# UNITED STATES PATENT AND TRADEMARK OFFICE

APPLICATION NO.	FILING DATE	FIRST NAMED INVENTOR	ATTORNEY DOCKET NO.	CONFIRMATION NO.
10/600,879	06/20/2003	Joel David Limmer	169.12-0587	6664

## Office Action Summary

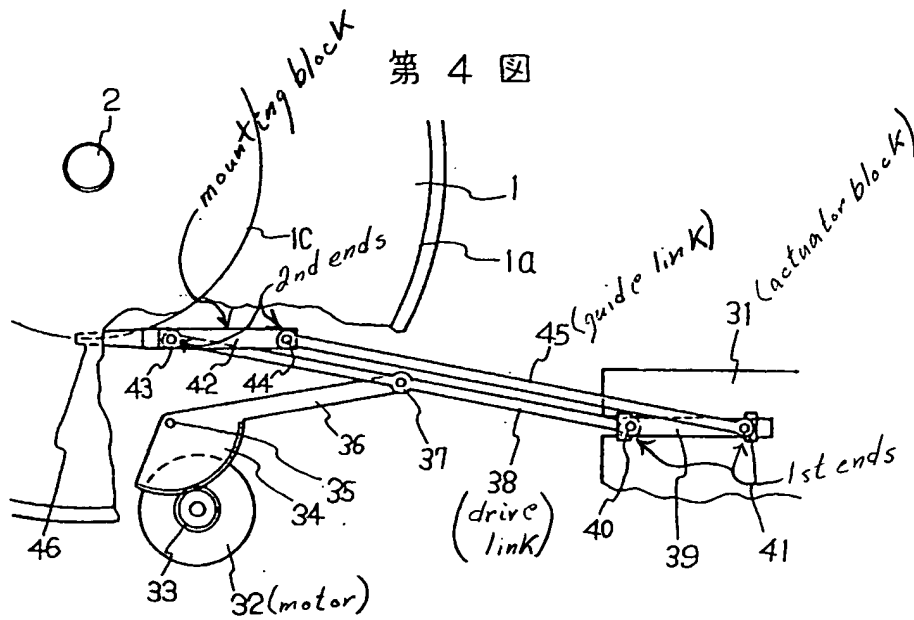
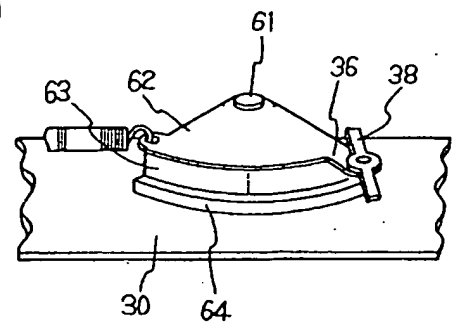
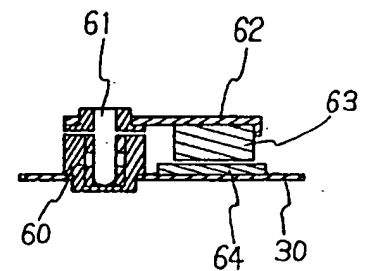
5. Claim 1-4,6,12,13 are rejected under 35 U.S.C. §102(b) as anticipated by the Japanese patent document (59-28216).

Note, to the extent claimed and understood, the structure as shown in Addendum BC (supplied with this office action) reads on and performs to the same degree as claimed.

The actuator motor 32 is operatively connected to drive link 38 via arm 36.

Re claim 4; because the claim fails to specify what is meant by 'flexible' and since all materials have some degree of elasticity or flexibility, the Japanese patent document's guide link is consistent with being a 'flexible' link.
